BNE Energy, Inc. Petition For a Declaratory Ruling That No Certificate of Environmental Compatibility and Public Need Is Required for the Construction, Maintenance, and Operation of a 4.8 MW Wind Renewable Generating Facility Located on Flagg Hill Road, Colebrook, Connecticut.

Petition 983

PETITION 983: BNE ENERGY, INC.'S RESPONSE TO THE CONNECTICUT SITING COUNCIL'S JANUARY 24, 2020 D&M INTERROGATORIES

DRAWN: SC APPROVED: CJ
 SCALE: N.T.S.
 DATE: 15 NOV 19
 PROJ. NO.: 3092 ARCH D_EJ
 CAD FILE NAME: 3092 ARCH D_EJ
 DRAWING NO.: **E101**

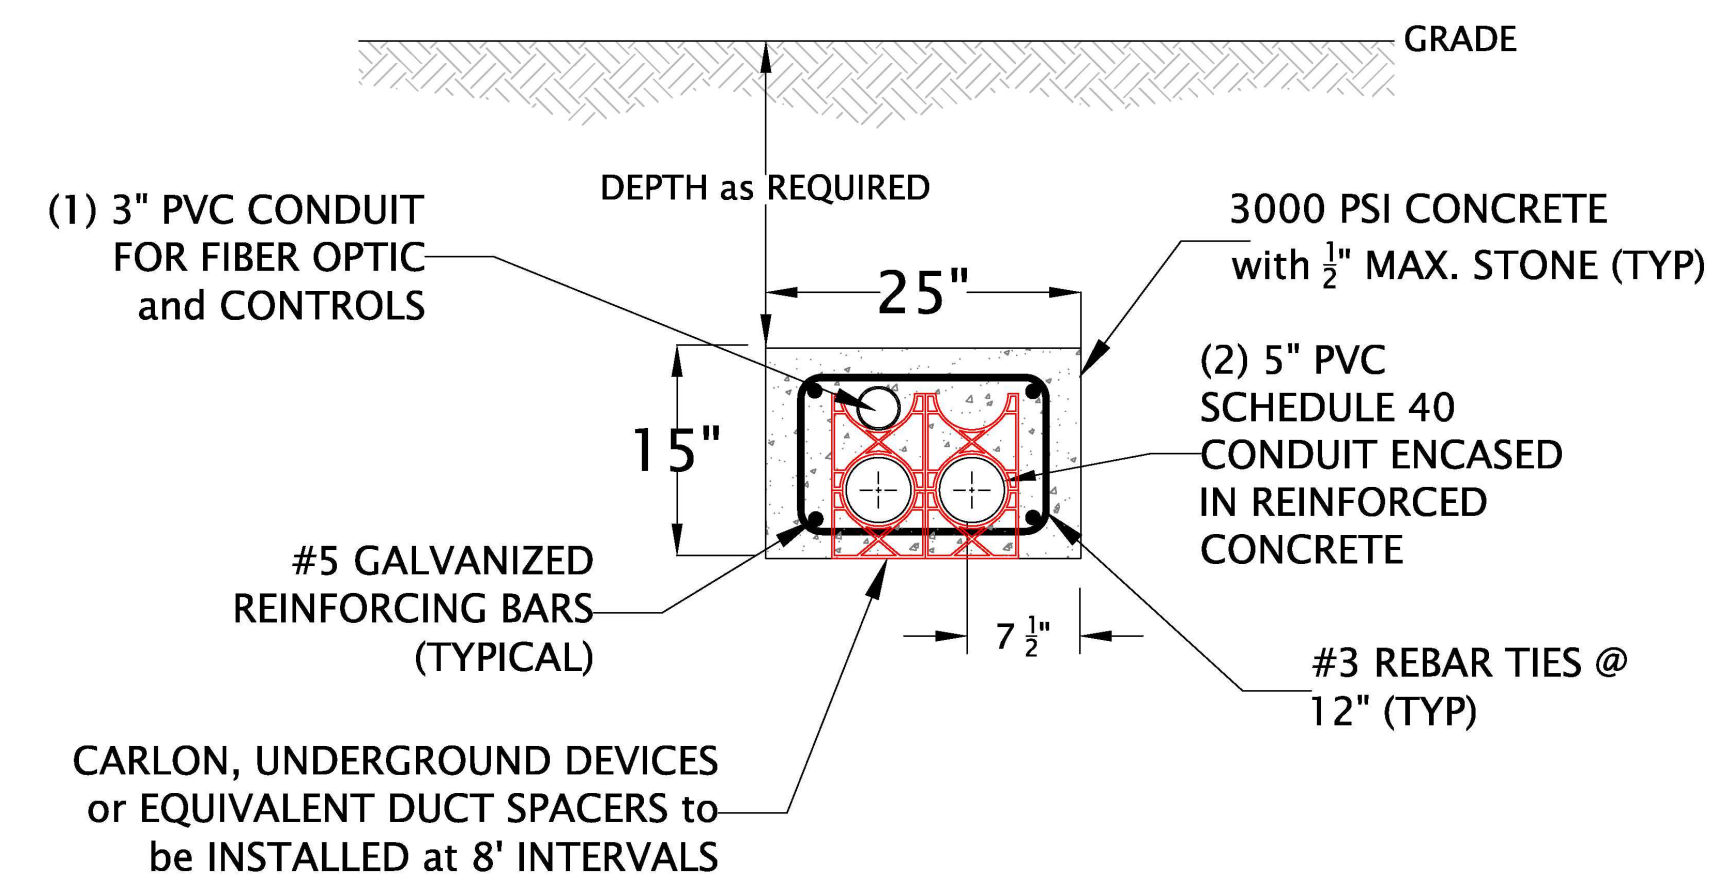
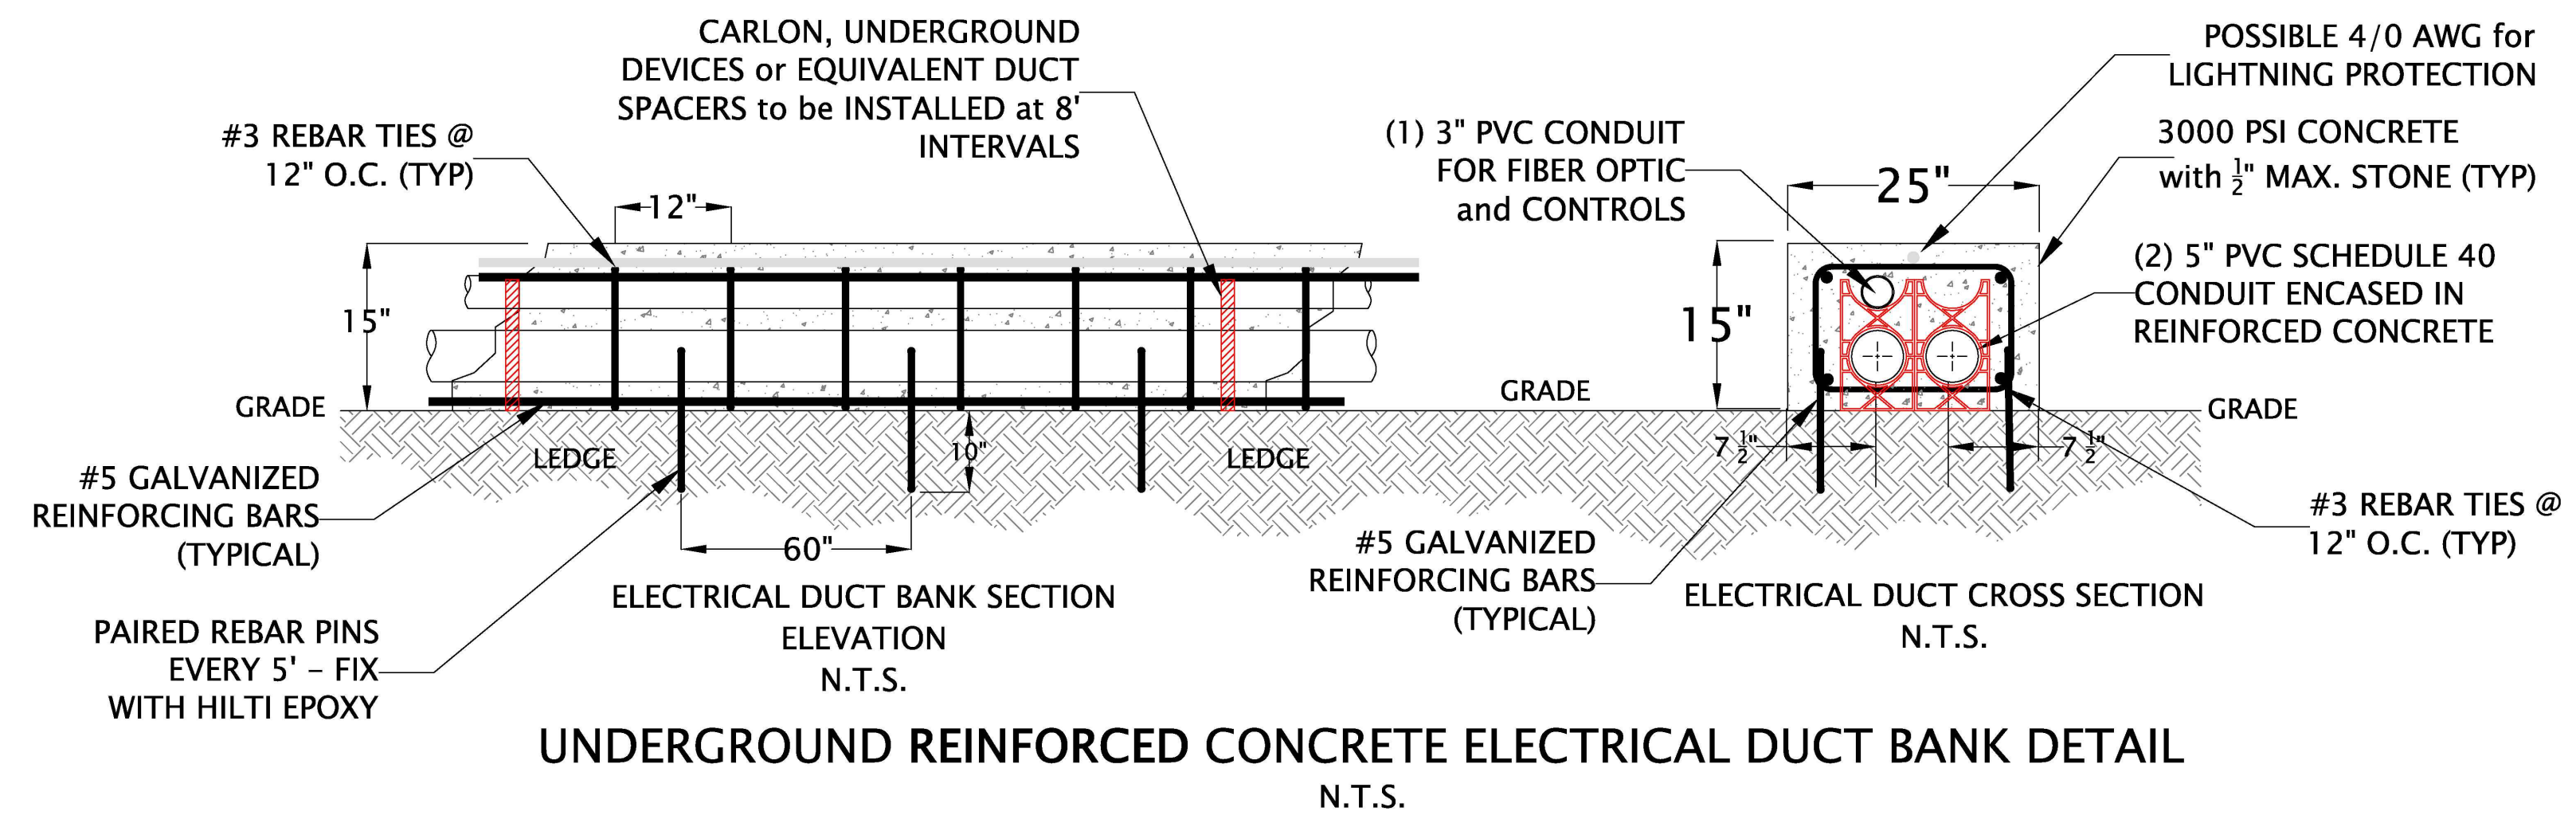
- 20. Referencing Drawing E102 of D&M Plan Modification, why are two 5-inch electrical conduits proposed in the duct bank? Would there be two circuits?**

Answer: There are two 5-inch electrical conduits proposed in the duct bank consisting of one conduit for the power cable and one spare conduit (for use if a cable fault causes duct damage).
